WATERLINE NO. 1

WATER DISTRIBUTION SYSTEM IMPROVEMENTS
 CITY OF BENTON, BUTLER COUNTY, KANSAS

Sheet 3 of 18

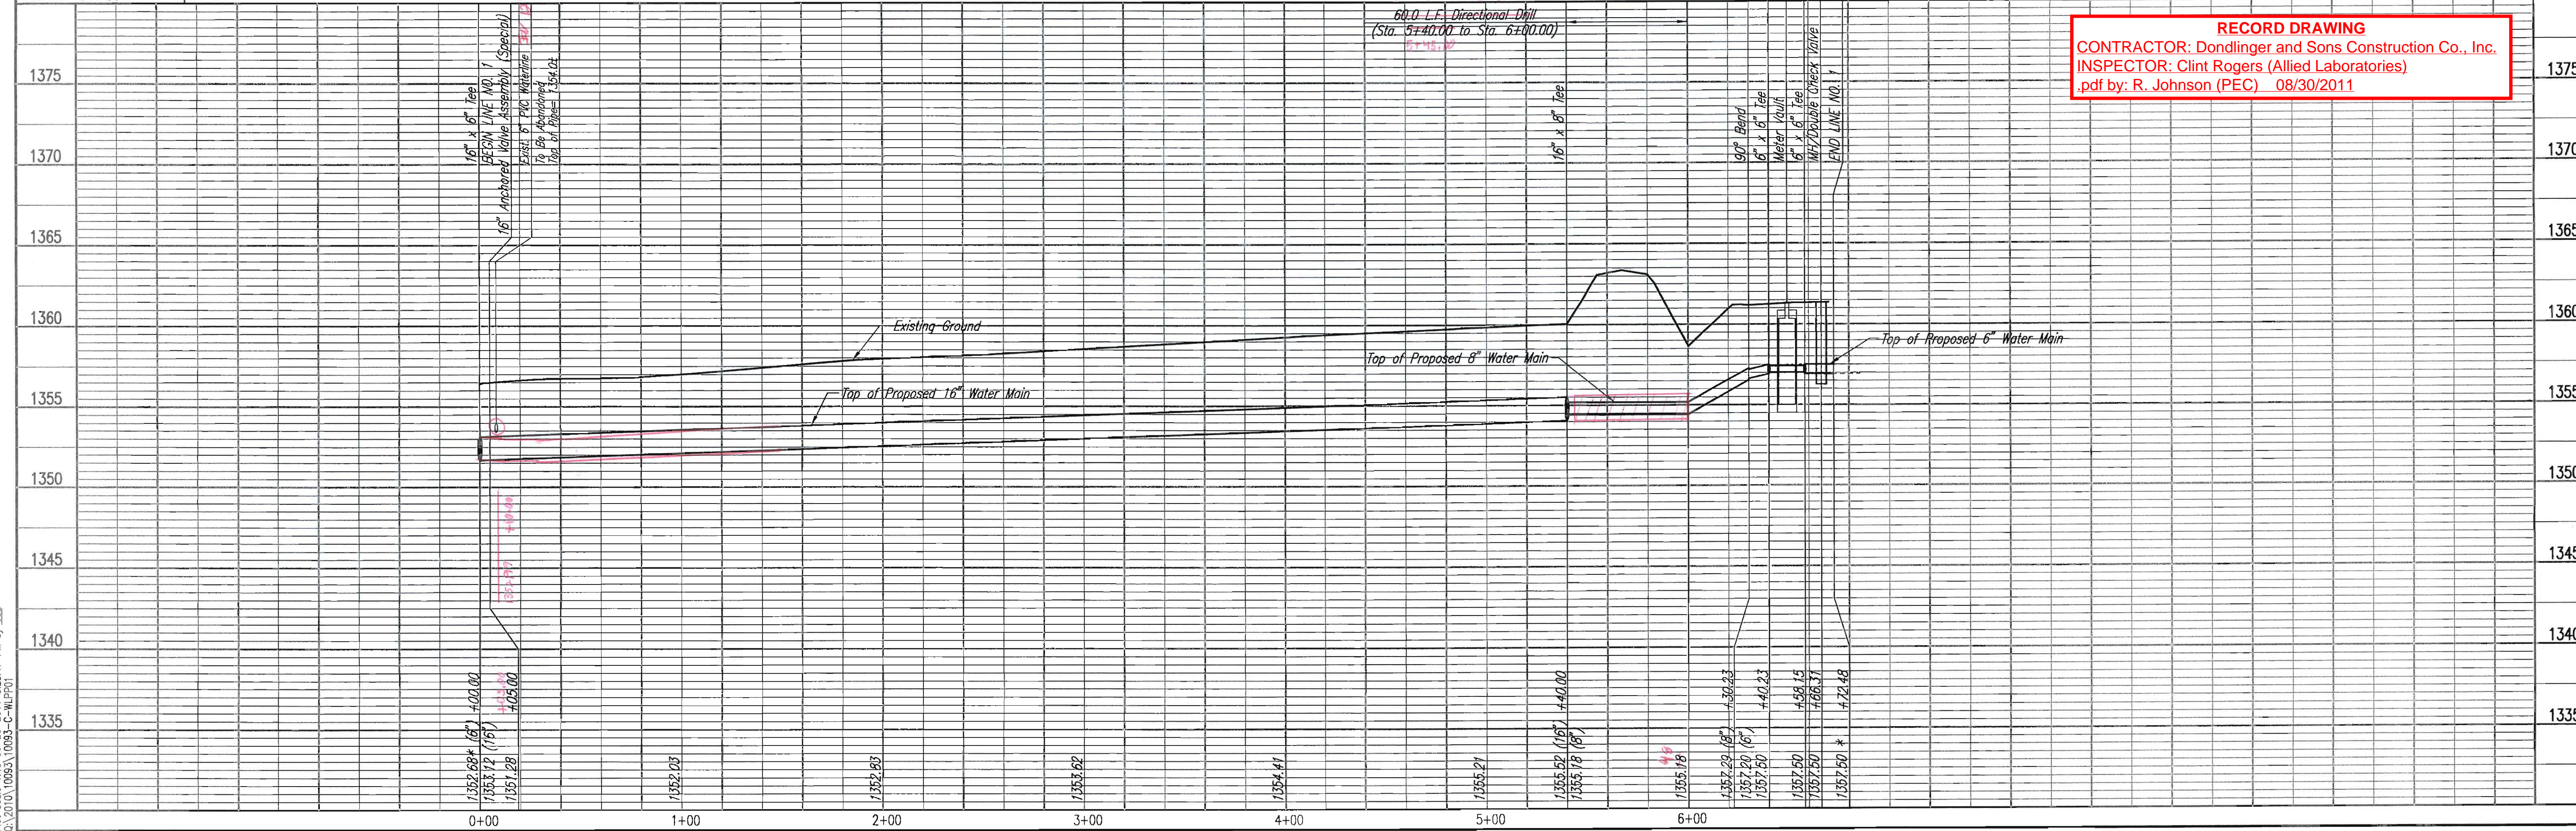
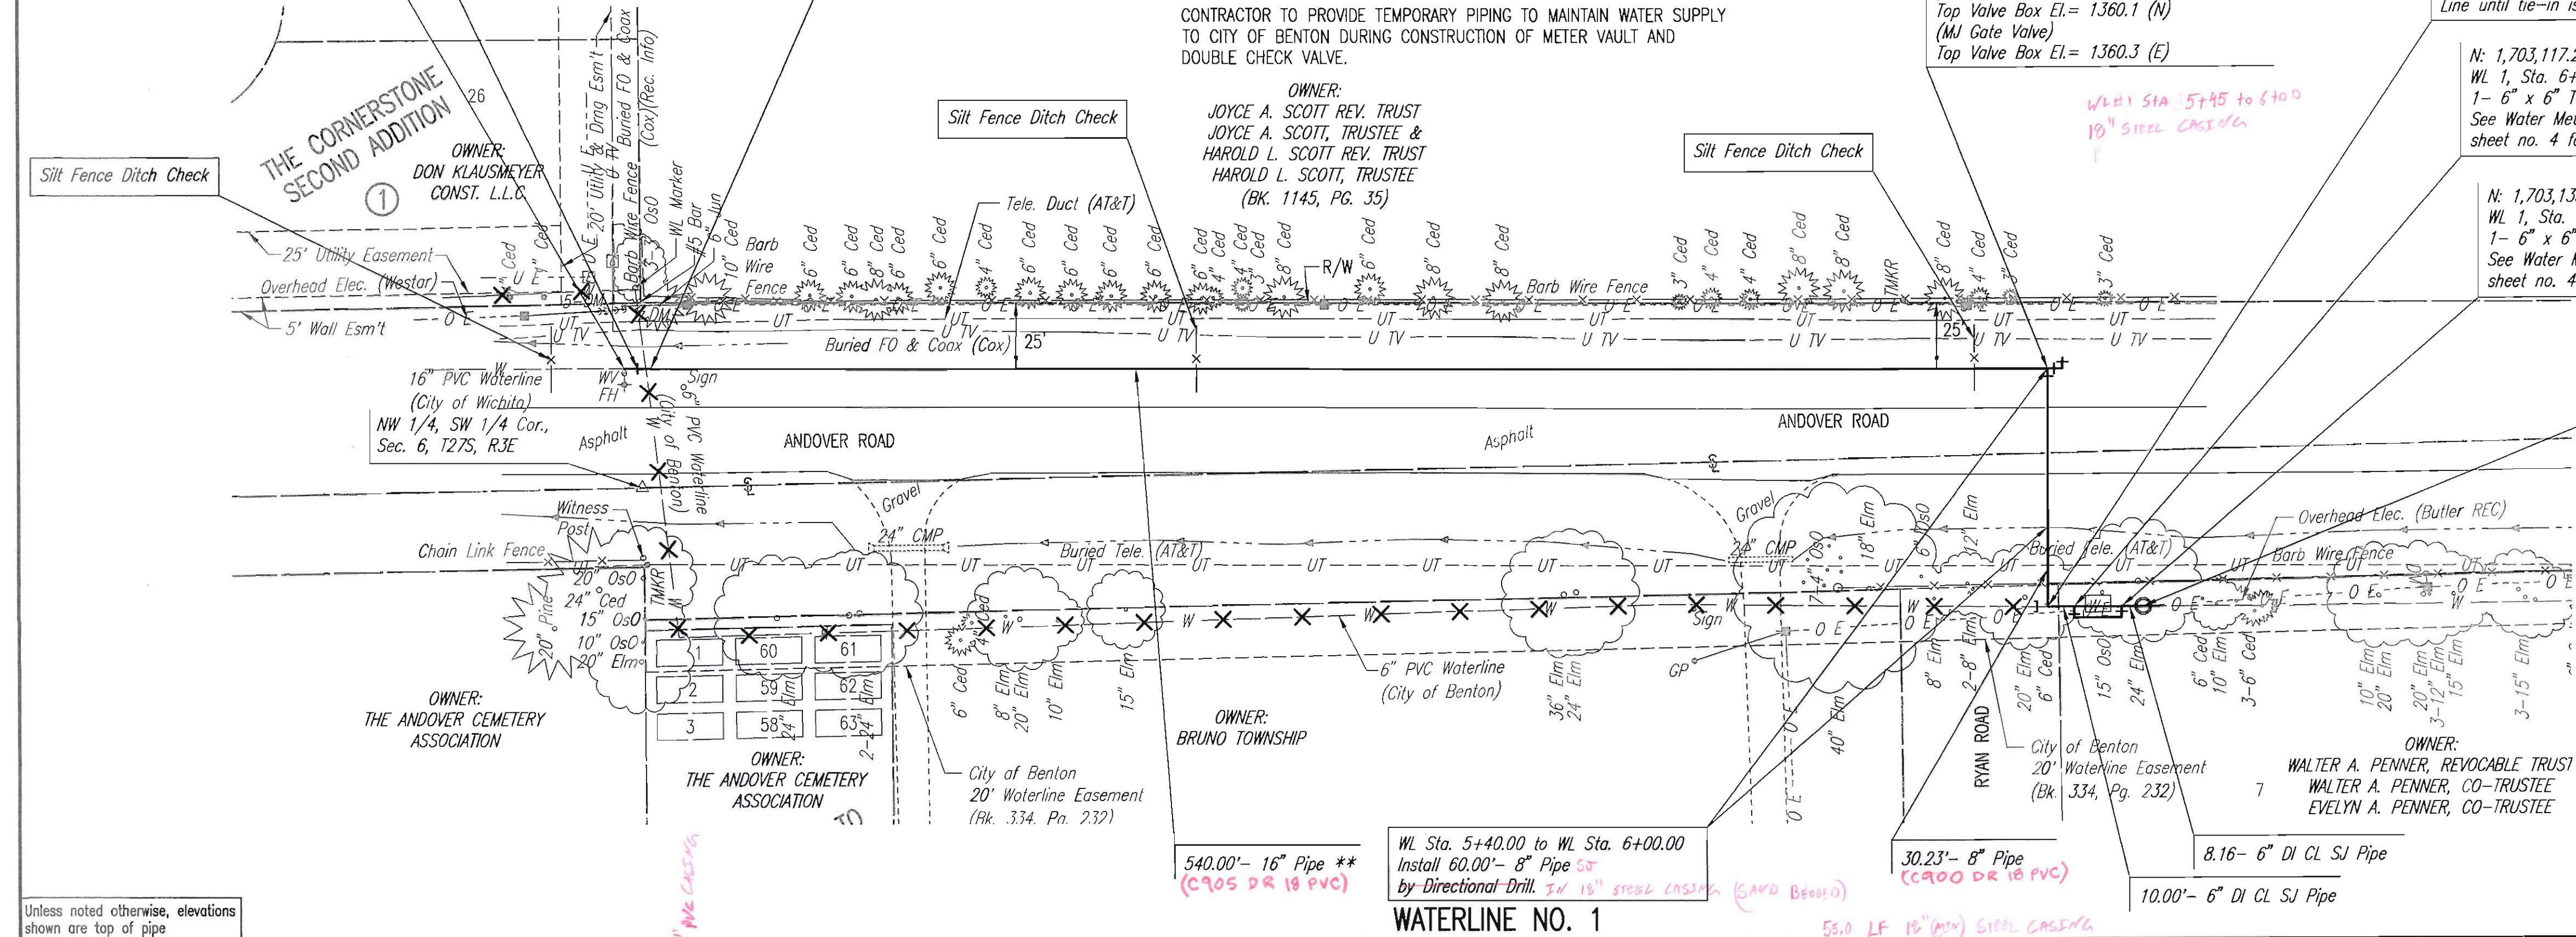
** ALTERNATE NO. 1 ~~was not used~~
 ALL REFERENCES TO 16" PIPE, FITTINGS, AND VALVES SHALL BE CHANGED TO 8" FOR ALTERNATE NO. 1. ALL REFERENCES TO 16" MJ BUTTERFLY VALVES SHALL BE CHANGED TO 8" MJ GATE VALVES.

AT STATION 0+00.00, CONTRACTOR SHALL INCLUDE 1- 16" x 8" REDUCER WHICH SHALL BE SUBSIDIARY TO THE PRICE BID FOR 8" PIPE.

AT STATION 5+40.00 BID ITEMS SHALL BE REVISED AS FOLLOWS:

- 1- 8" x 8" TEE
- TEE SHALL BE KEY BLOCKED
- 1- 8" ANCHORED VALVE ASSEMBLY (N)
(MJ GATE VALVE)
- 1- 8" VALVE ASSEMBLY (E)
(MJ GATE VALVE)
- 3.00'- 8" DI CL SJ PIPE (N)
- 1- 2" BLOWOFF ASSEMBLY (N)
- TOP OF VALVE BOX EL= 1360.1 (N)
- TOP OF VALVE BOX EL= 1360.3 (E)
- TOP OF PIPE ELEVATION FOR 8" x 8" TEE = 1355.18
